RE: TAC Response to Comments & Rev 5 Plan Submission
325 Little Harbor Road, Portsmouth, NH – Tax Map 205 Lot 2
Project #47099.01

REVIEW COMMENTS:

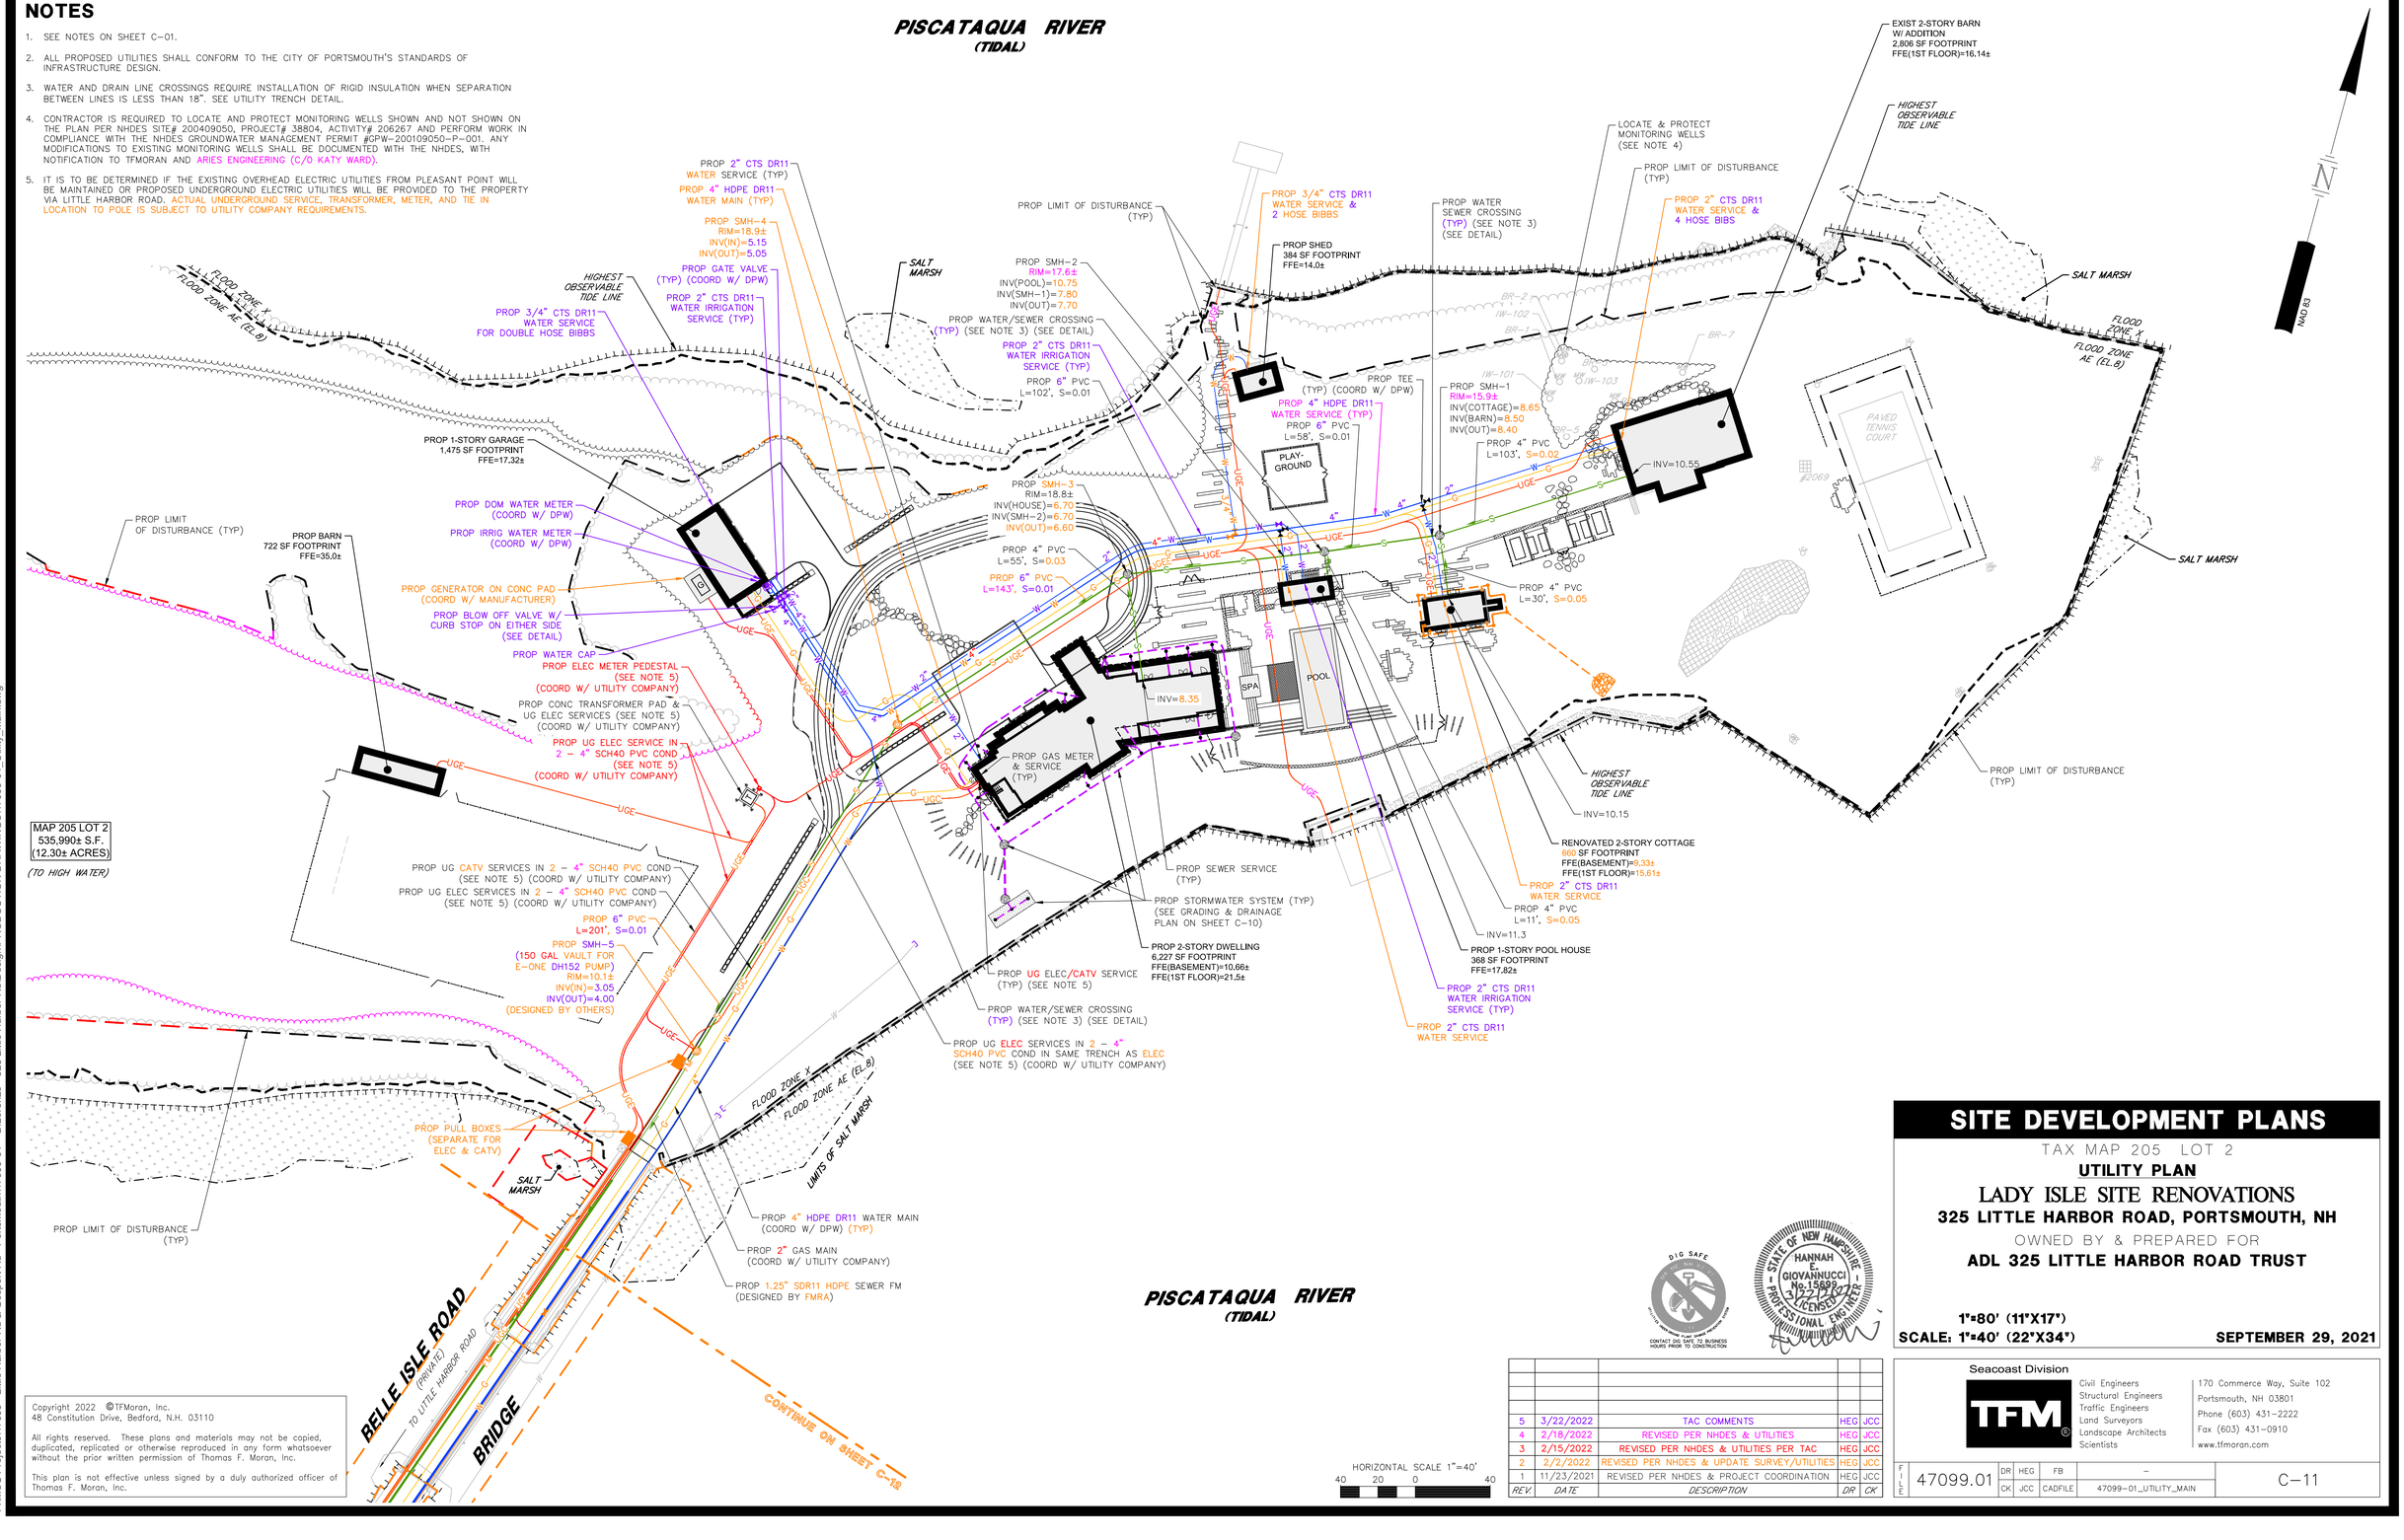
3. There can be no meter pits on the water main. The main must go directly into the principle structure for metering.

The water main has been reconfigured to remove the proposed water meter pit and redirect the water main towards the garage with mounted water meters: one for domestic and one for irrigation.

SEWER FORCE MAIN PROFILE

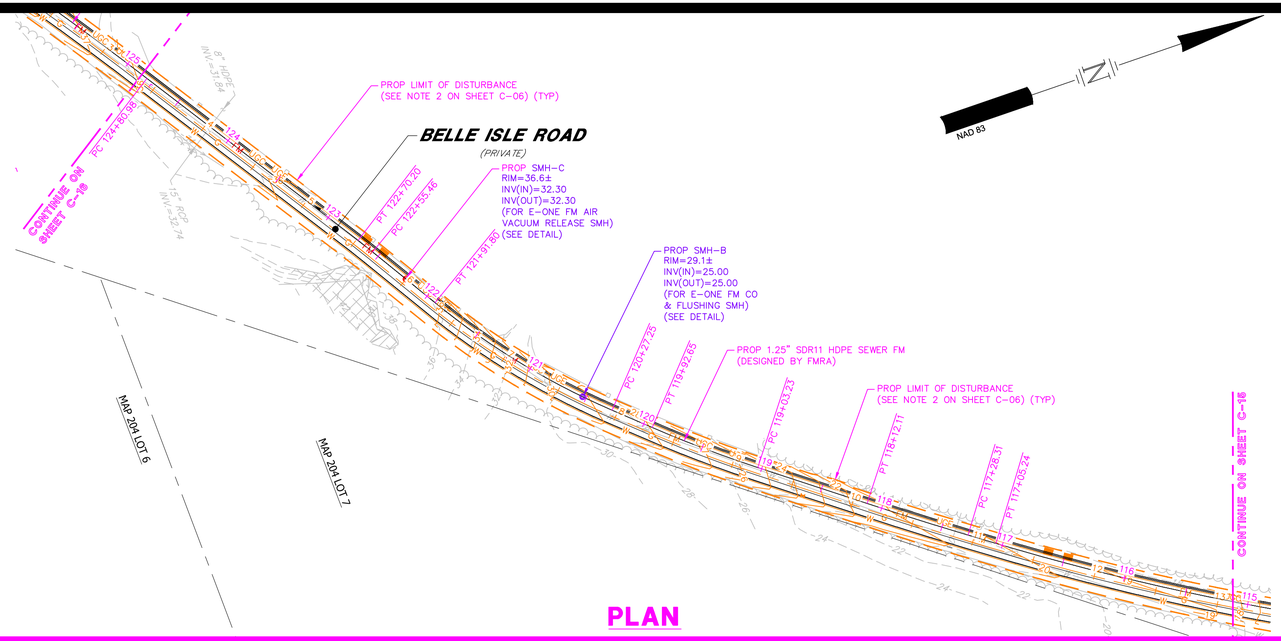
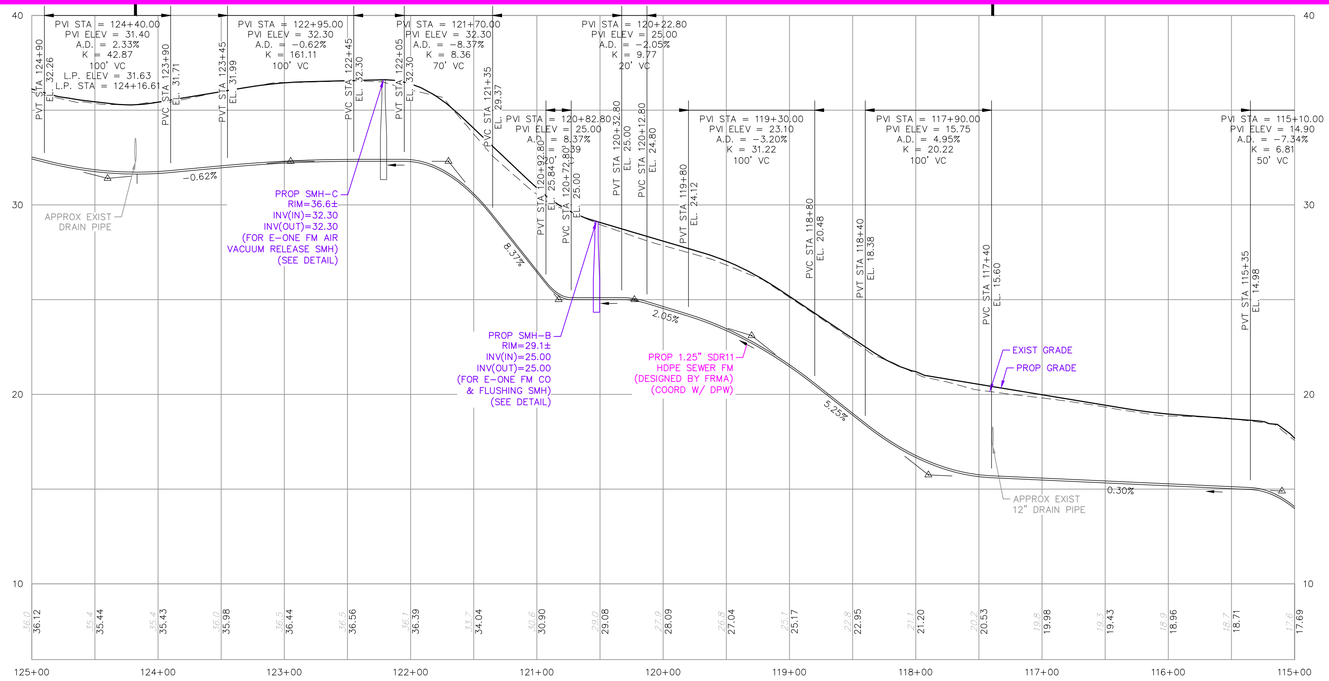
1. 1½" Diameter force main is the minimum the City will recommend.

All cleanout/flushing manholes and air vacuum released manholes provided by EOne include assemblies within the structure that are 1.5". While TFM's plan show a 1.25" diameter force main per the direction of the EOne designer, the pipe transitions to 1.25" diameter before and after the manhole.

For this project, the EOne designer recommends using force main pipe no larger than 1.25". This is the maximum size recommended for this design to reduce the length and volume of retention of sewage in the approximately 0.6 mile line. Increasing the entire force main line to 1.5" would increase retention time and the possibility of sewage turning septic.

The E-One designer confirms that 1.25" force mains are common. Force main cleanouts and flushing manholes have been located throughout the force main sewer at intervals greater than the 1,000 FT recommended by EOne. The cleanout/flushing manholes are designed to effectively flush water through the system to clear blockages, if any blockage should occur. Additionally, cleanout/flushing manholes are located at all low points. As discussed with FRMA, because EOne force main pumps include a grinder to reduce solid sizes, any blockages would likely occur directly at the pump or closer to the island. The majority of the sewer force main is upon private property, so only a quarter of the force main line is within the public ROW. In summary, the E-One designer does not have concerns regarding blockages with the proposed design.
